January 1, 1943

SERVICE LETTER NO. A-12.

Subject: Valve - Carburetor Heat Control Assembly No. 8290 - Modification of Linkage.

Figure 1-

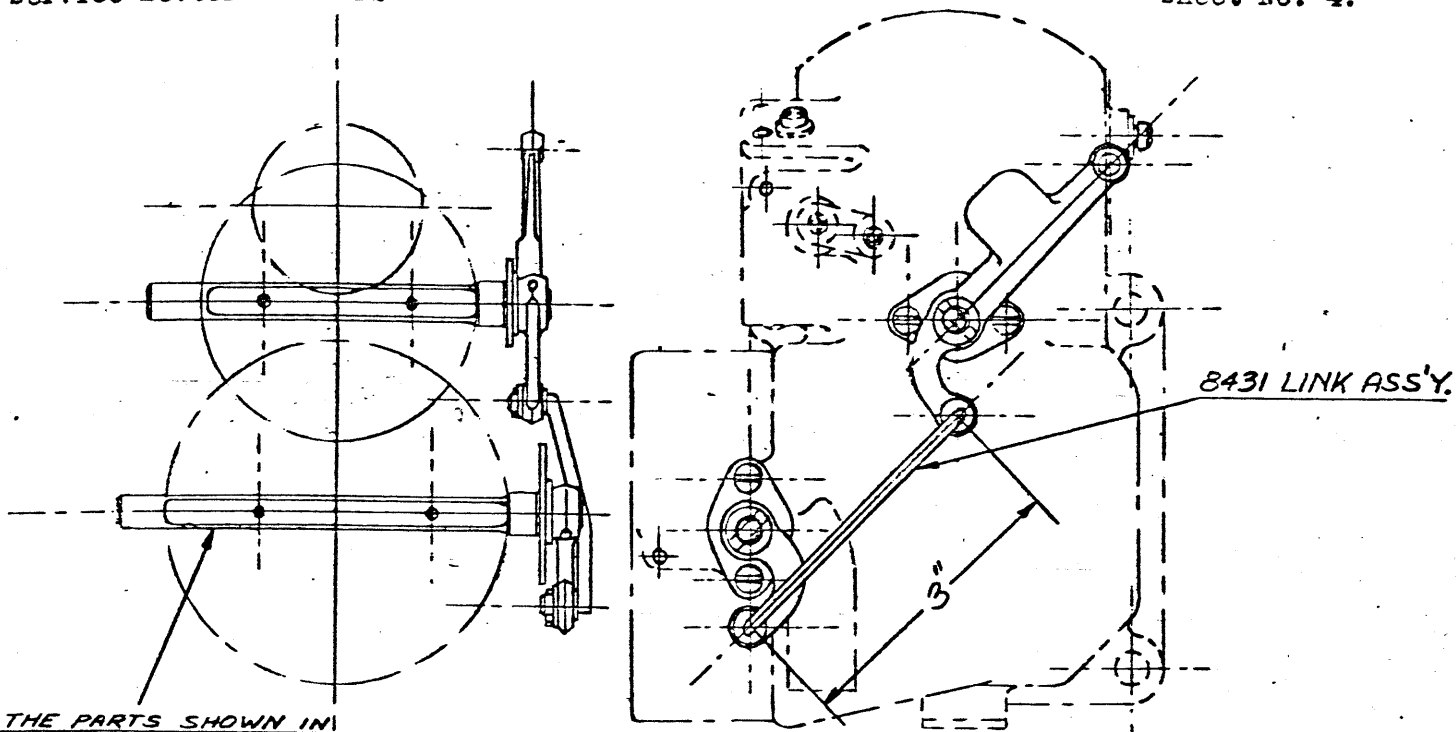
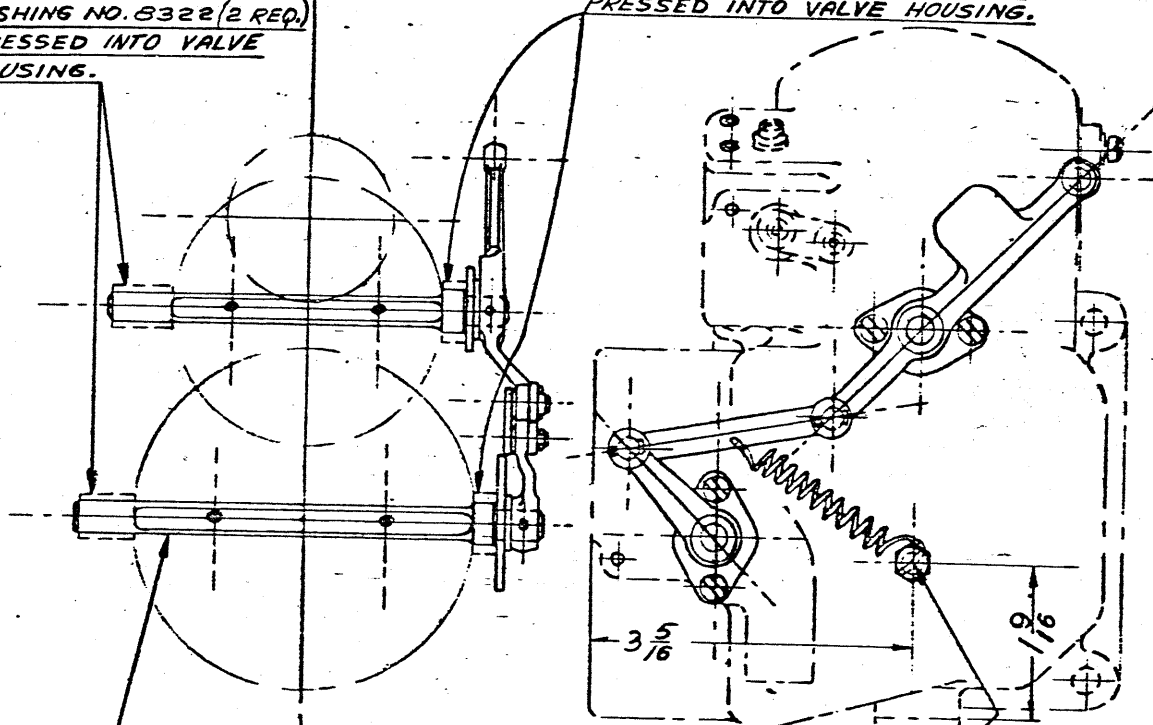
The following are the main differences between the old and new linkage:

- (a) The link assembly between the two levers in the old linkage was assembled from the bottom. Whenever the cotter pins retaining this rod would wear through due to vibration, the rod would drop off which may result in both the hot and cold valves closing causing a forced stop of the engine.

- (b) In the old linkage, the two levers were a reamed fit on the shafts and were retained by two taper pins. Vibrations had a tendency to permit the levers to become loose on the shaft. To eliminate this condition, on the latest linkage the shafts are silver soldered into the levers in addition to being pinned.

- (c) A spring has been added to the linkage which serves two purposes. In case of a failure of the control between the heater valve and the cockpit, the spring moves both the cold and hot butterfly valves into a half-open position so that such a failure does not cause a forced stop of the engine. Secondly, this spring maintains a constant load on the lever and connecting link, thereby eliminating wear due to vibration.

The latest No. 8290 Heater Valve, No. 8290, Ch. "E", is equipped with the linkage as shown below in Figure 2. Assembly No. 8646 has been assigned to the linkage shown in Figure 2 which includes the shafts to which the levers shown are attached, the link assembly, and also the spring and spring anchor screw.

The design of the old and new linkage are such that the new linkage can be installed in lieu of the old linkage in any heater valve in service.

Figure (2A)

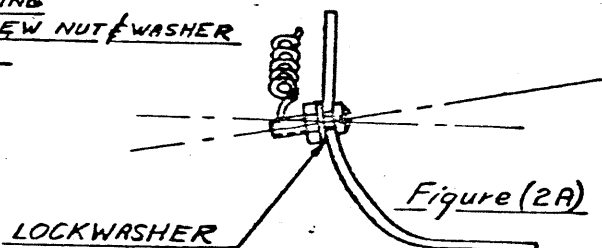
- (a) If it should be desired to install the new 8646 linkage in lieu of the old linkage, the entire new linkage assembly, as shown in Figure 2 in solid lines, including the spring and spring anchor bolt, can be ordered from The Warner Aircraft Corporation under the part No. 8646. This assembly number does not include the 8322 and 8311 bushings described above under "Repair of Old Linkage". These bushings must be ordered separately if their replacement is found necessary.
- (b) After the old linkage has been removed, as described above under "Repair of Old Linkage", the 13/64" diameter hole for the spring anchor bolt, as shown in Figures 2 and 2A, must be drilled and the anchor bolt installed as shown in Figure 2A.

WHEN INSTALLING THIS LINKAGE DRILL 3/8 DIA. HOLE IN HOUSING NR 8291 IF NOT ALREADY DRILLED.
